The Farm at Wilson Lane /
Final Approval

CITY COUNCIL MEETING STAFF REPORT

Subject: The Farm at Wilson Lane - Final Review

THE FARM AT WILSON LANE SUBDIVISION PLAT

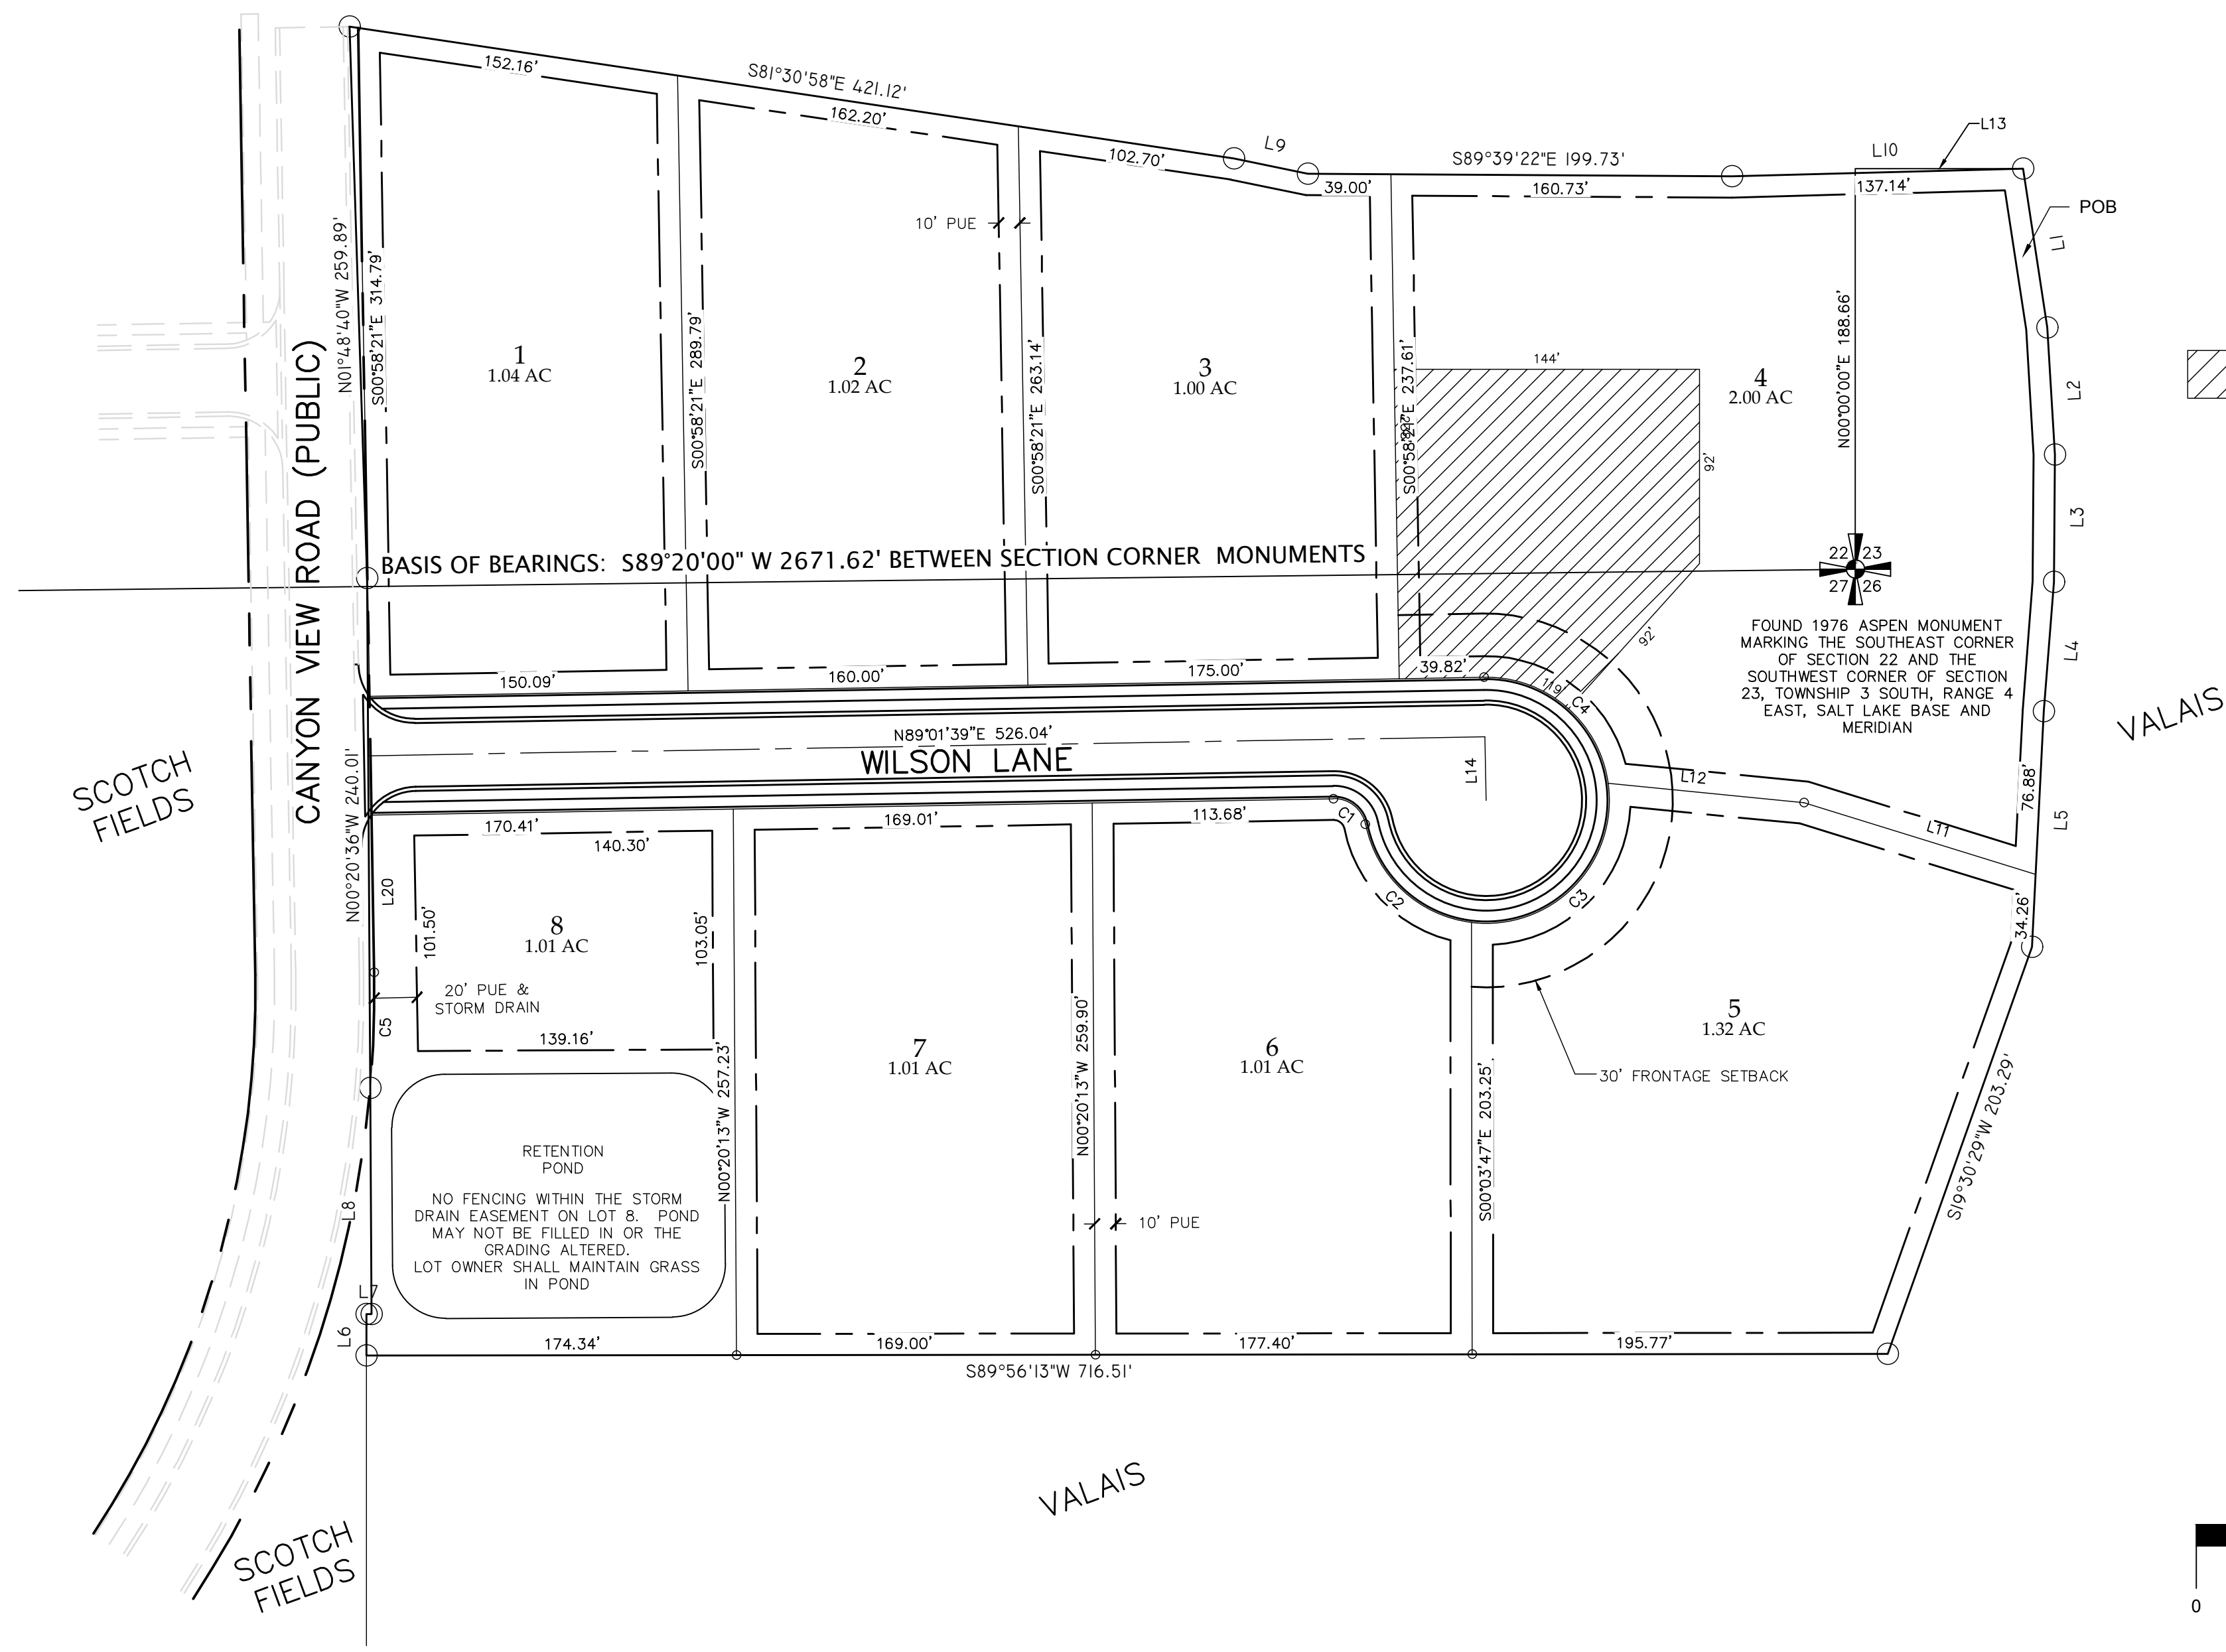
Open Space – Standard subdivisions greater than 10 acres in size are required to provide a minimum of 15% open space. The applicant has elected to incorporate the required 1.54 acres of open space into lot four, which is allowed if the lot size is a minimum of two acres, which it is. The portion of the lot that counts towards the required open space obligation needs to be clearly identified on the plat along with a note stating that the open space is unbuildable and clarifying what uses can occur on the open space.

Storm Water – Storm water runoff will be captured and retained onsite in a pond located on lot 8. The applicant will need to ensure that the storm drain easement on lot 8 is clearly marked on the plat. They will also need to include a 15’ wide (minimum) access easement connecting the pond easement to the right-of-way for future emergency access. The plat will also need a note requiring the owner of lot 8 to provide a 10’ (minimum) access gate in the event that a fence or some other type of barrier or obstruction is proposed to be erected on the lot inhibiting access over the access easement.

OVERALL UTILITY PLAN

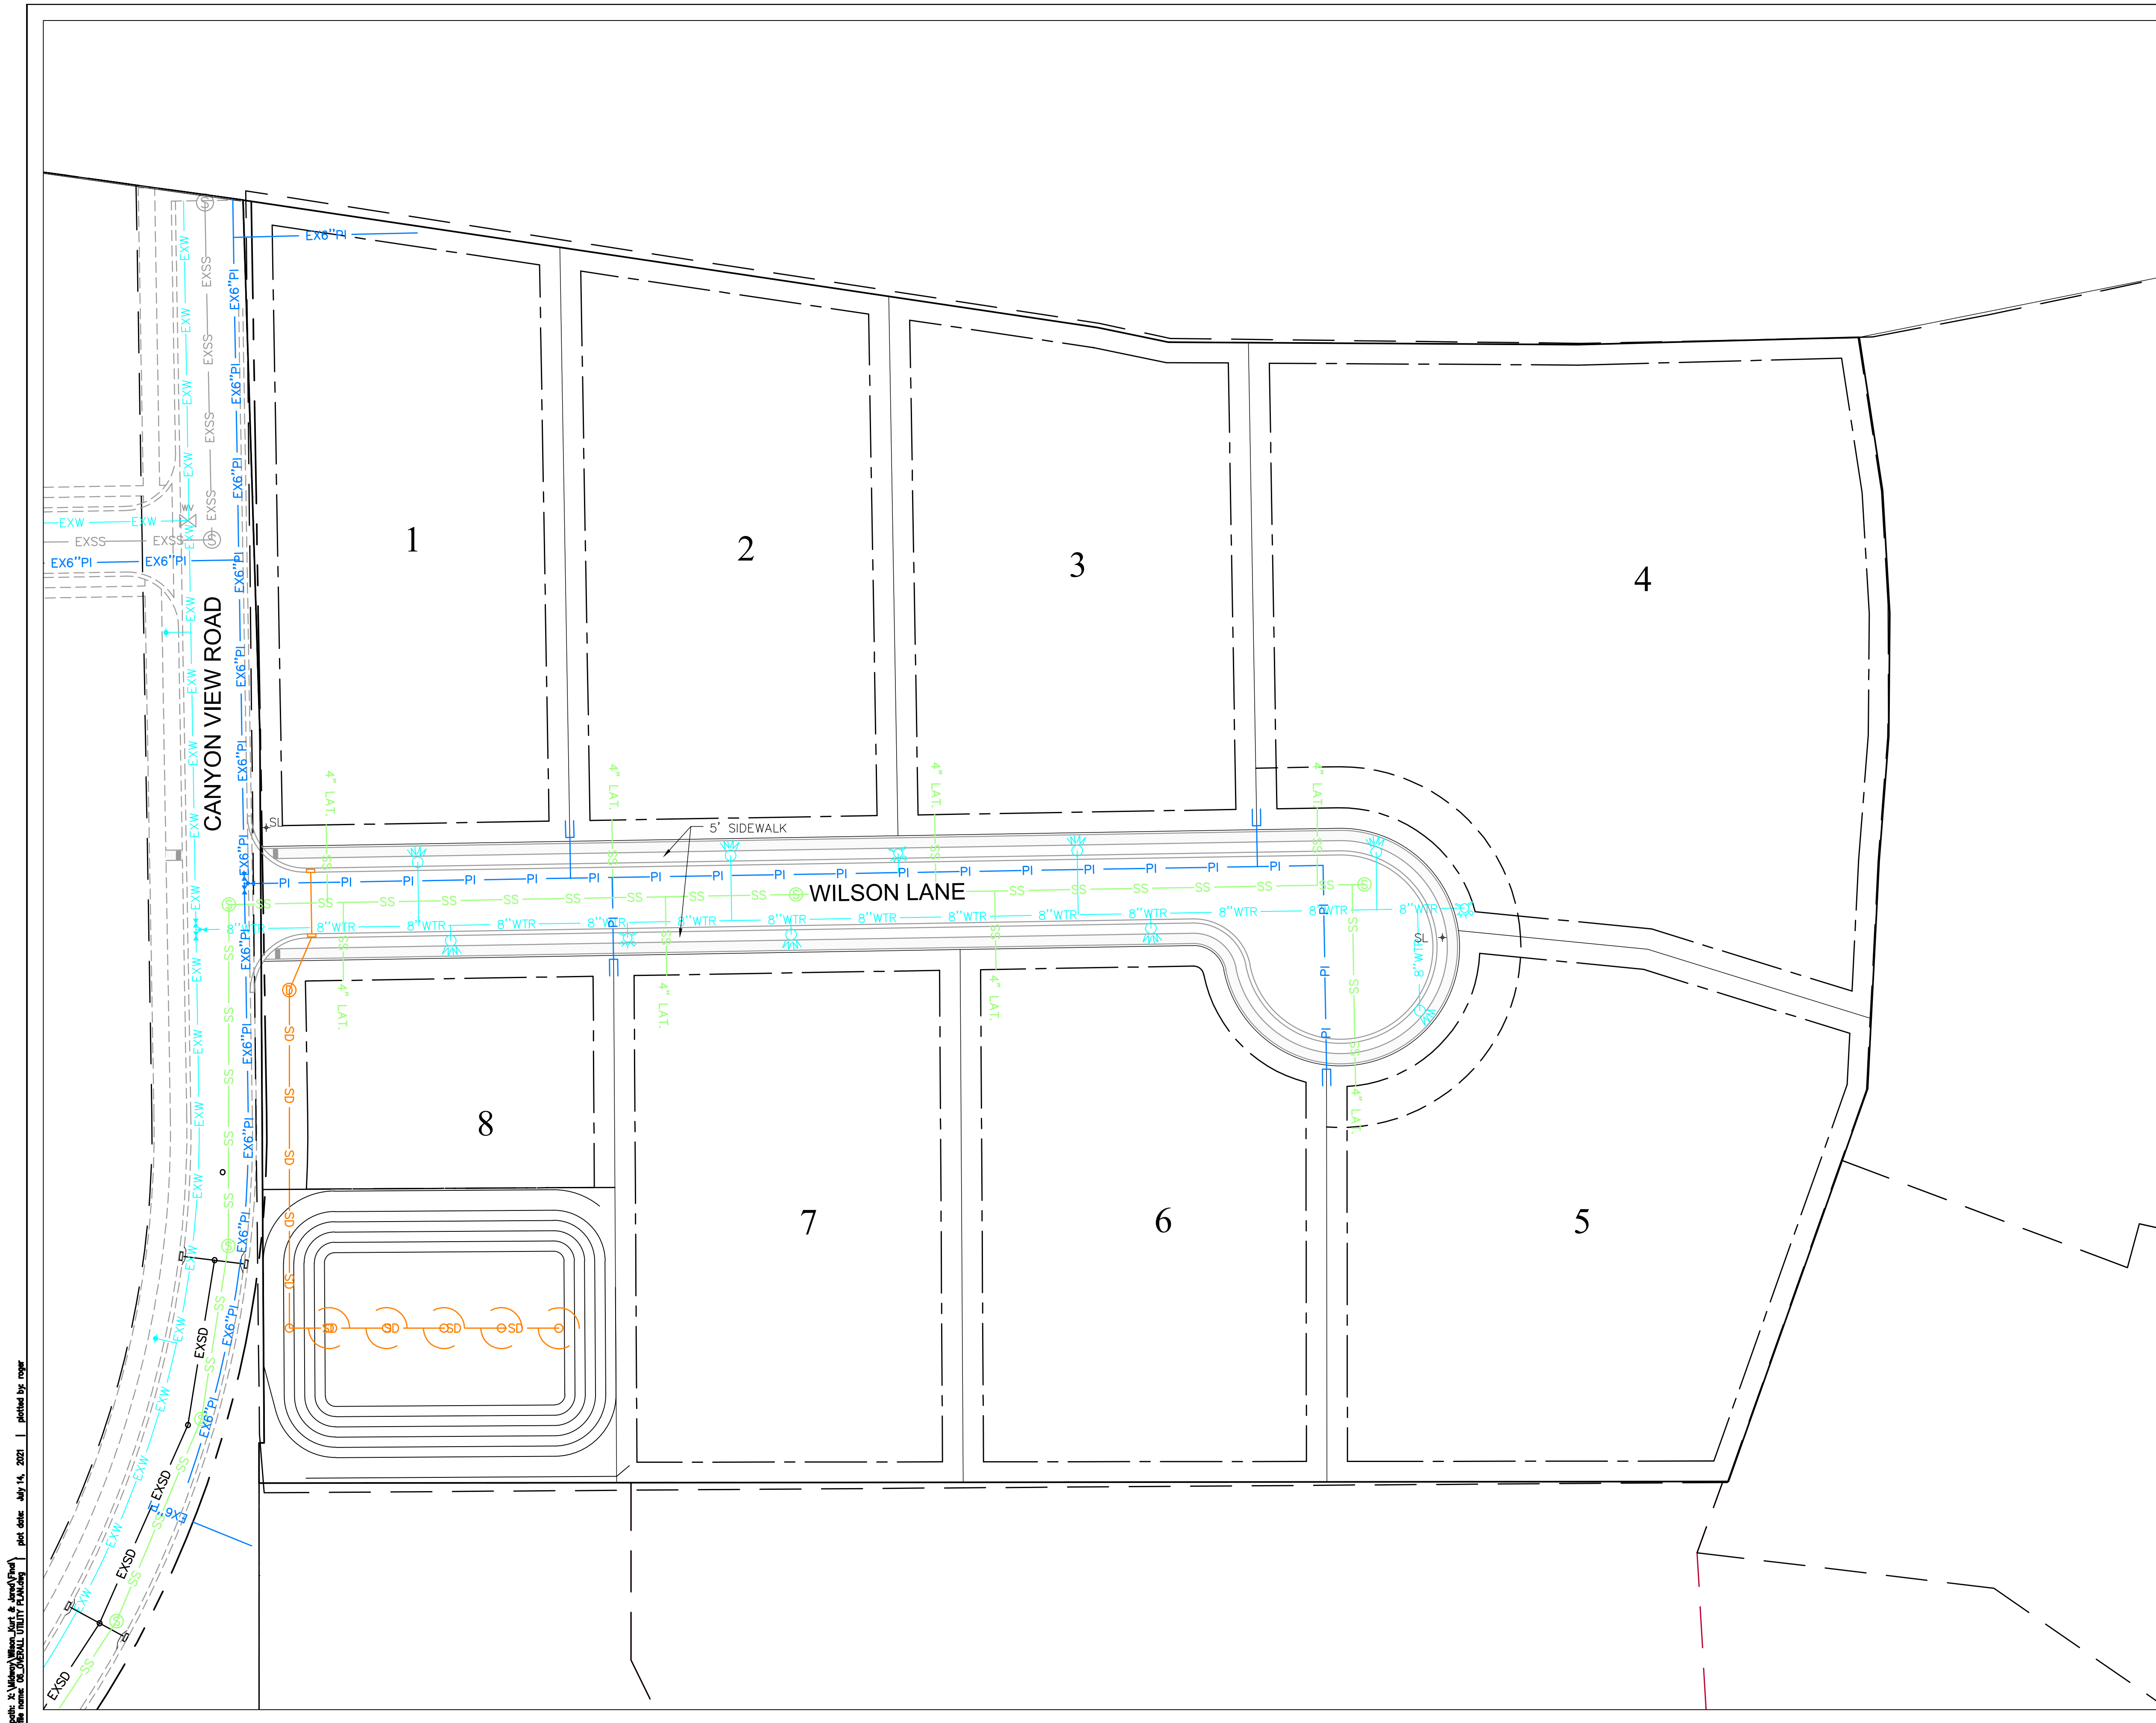
- The proposed development will be served from the Cottages on the Green pressure zone.
- The proposed development will connect to the 10" culinary water line that is in Canyon View Road.

- The proposed road within the subdivision will be a 56' public right-of-way with sidewalk on both sides of the road.
- All patches within Canyon View Road shall be done with a paver and at a minimum be paved back at the half width of the roadway.

- The storm drain system will be public and will be collected within the proposed curb and gutter and discharged to a series of catch basins, sumps, and retention basin within the development.
